Mixed Use Development 903-921 Bourke Street , Waterloo – Objection

28 April 2026

Fig.1 Proposed increased heights (*Environmental Impact and Rezoning Statement*, p. 50)

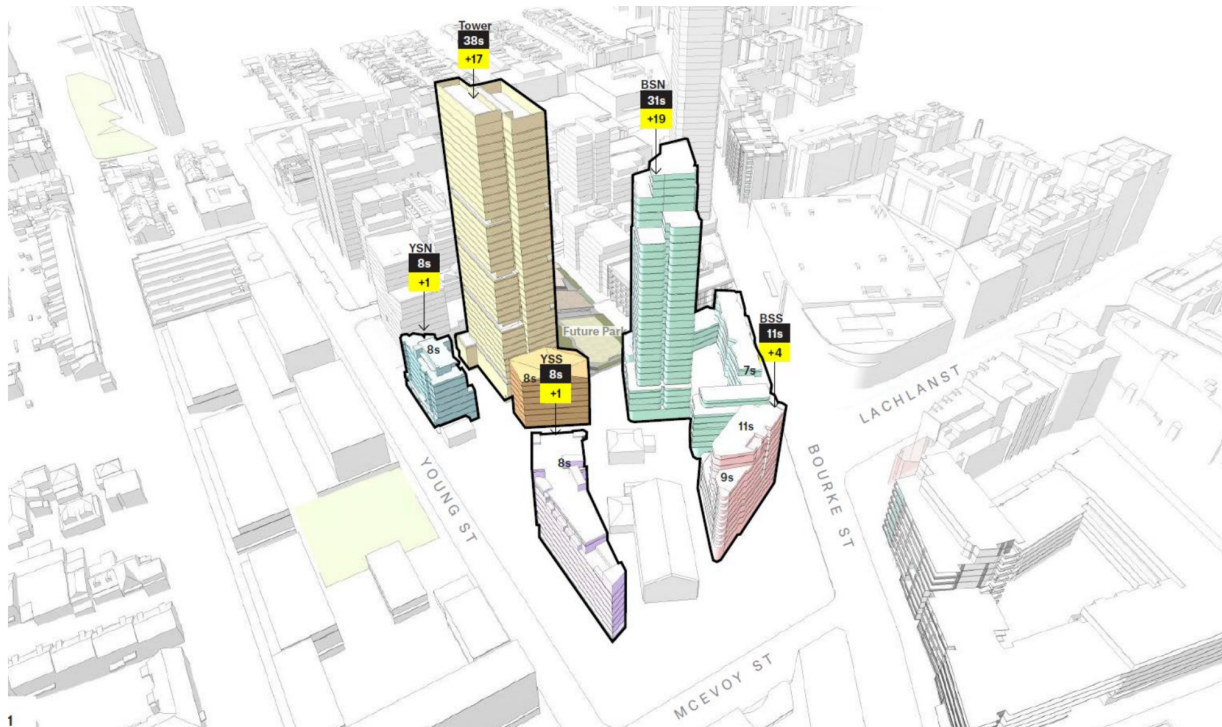
I attended the online community session hosted by Sarah George Consulting. During that session, the project architect explained that they are proposing a modest and subtle increase of the towers, and I would like to enquire what is so modest and subtle about increasing 16 and 18 storeys on the towers?
